DATE: 09.25.2017
TO: ProTrak
FROM: Mitesh Baxi Traffic Engineering

■ **RENAISSANCE MARKET [TRC Plan Review]**

↻ Initial Review Note ↻

TECHNICAL STANDARDS – NEW ROADS:

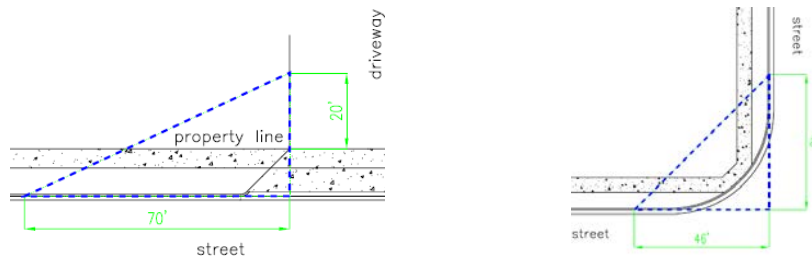
1. Show a cross-section detail showing the existing Sir Tyler Dr and the proposed widening.
2. The proposed diagonal wheelchair ramp at the corner of Sir Tyler Dr and existing driveway to the south of the property is not designed as per NCDOT and/or City standards. Please revise the design as per [CofW SD 3-09](#).
3. The minimum street corner radii is 35’. [\[7-5 CofW Tech Stds\]](#)
